STORM SEWER IMPROVEMENTS to serve **VERANDAS AT CRESTVIEW APARTMENTS** 300 NORTH 127TH STREET EAST CITY OF WICHITA, KANSAS, 67206

Project Number
 2021-000671PPD (ORG CODE 56030970)

PPD PLAN

CU711

3 PPD PLAN - STORMWATER LINE 2 PLAN & PROFILE

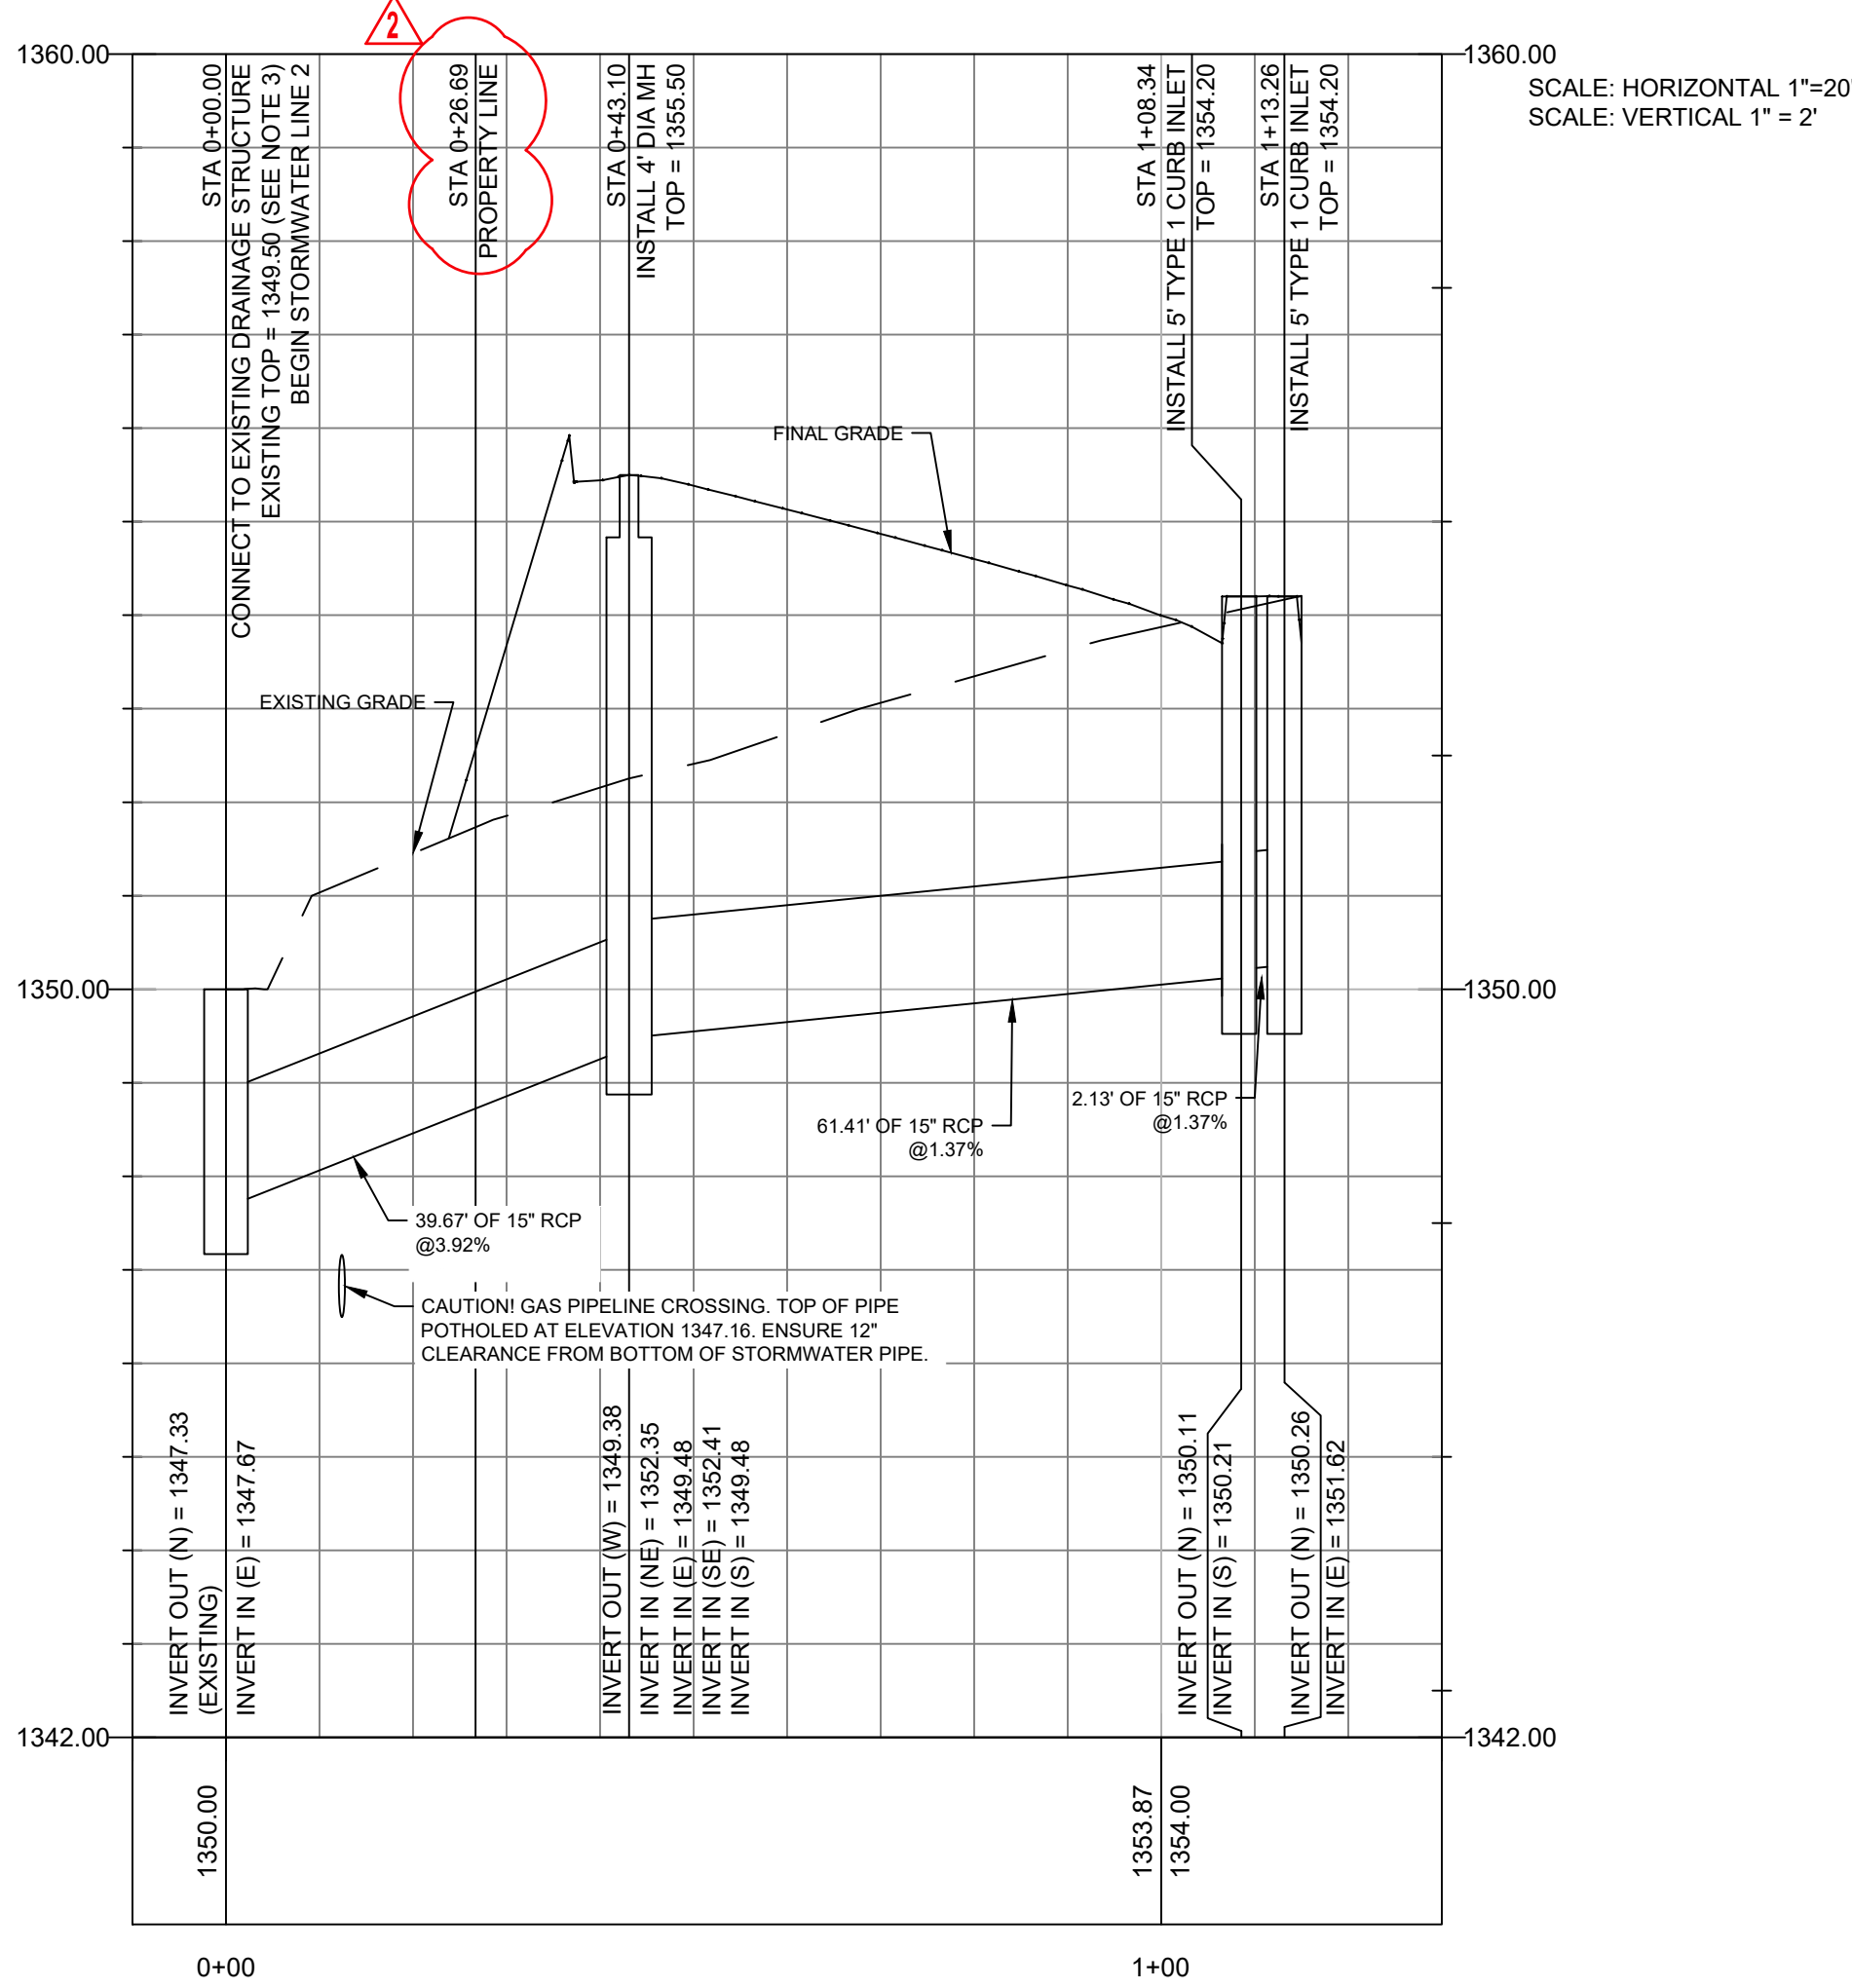
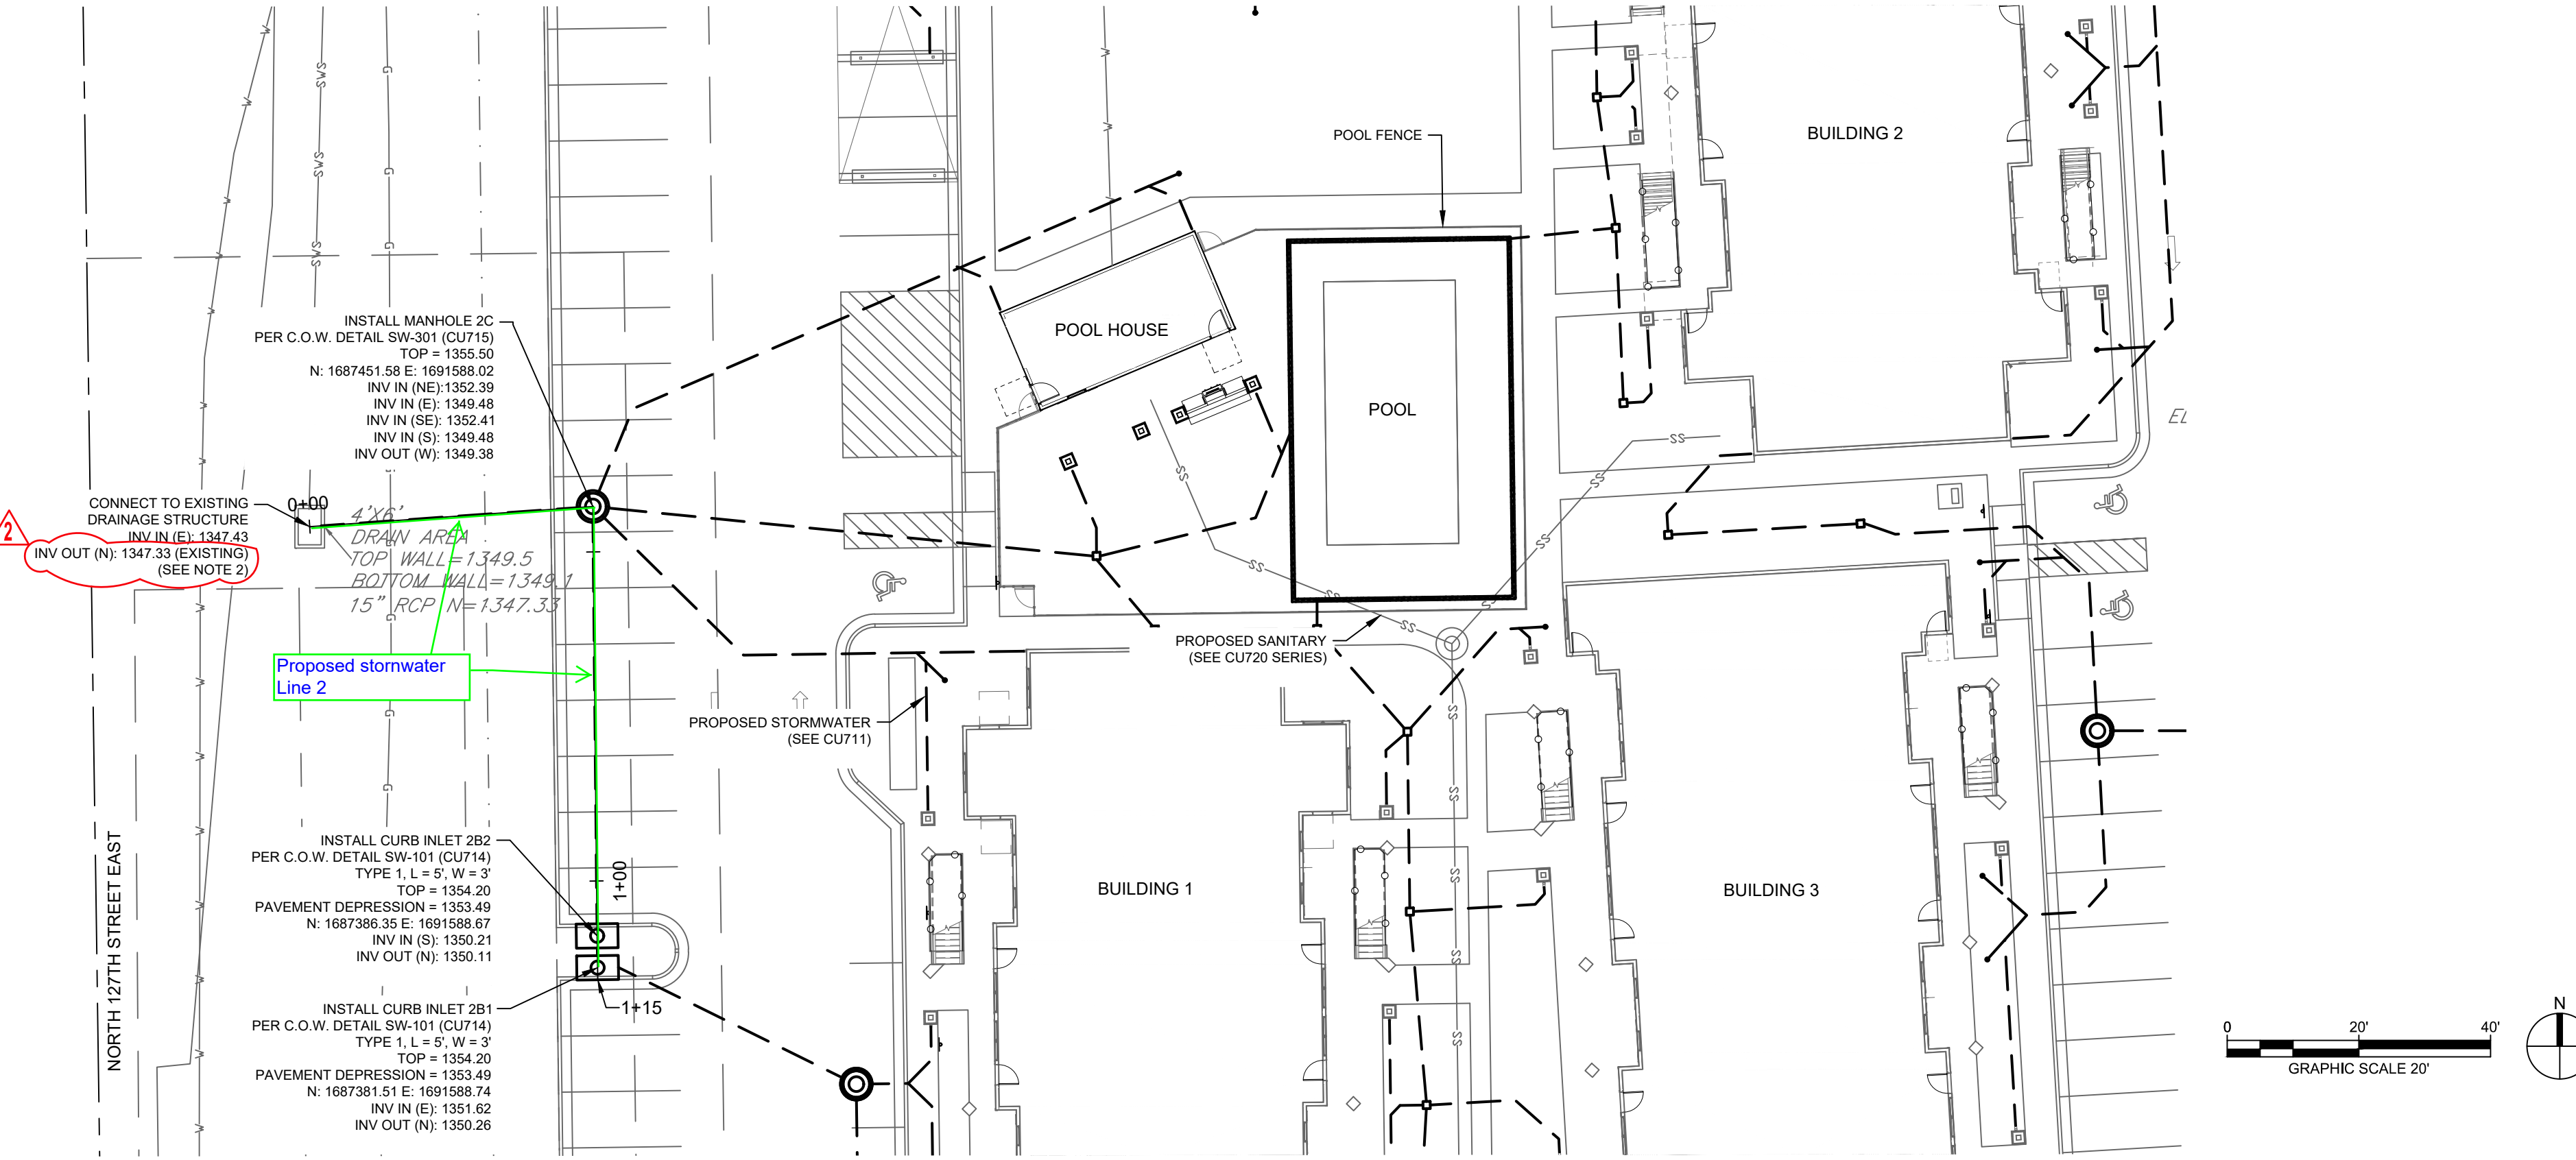
EXTENSIVE REVISIONS:
 1. ADDED CURB INLET 2B2 TO KEEP ALL INLETS WITHIN PROPERTY LIMITS.
 2. MODIFIED LOCATION OF MANHOLE 2C.
 3. REVISED INVERT ELEVATIONS IN ORDER TO ACHIEVE 12" CLEARANCE FROM PHILLIPS 66 PIPELINE.
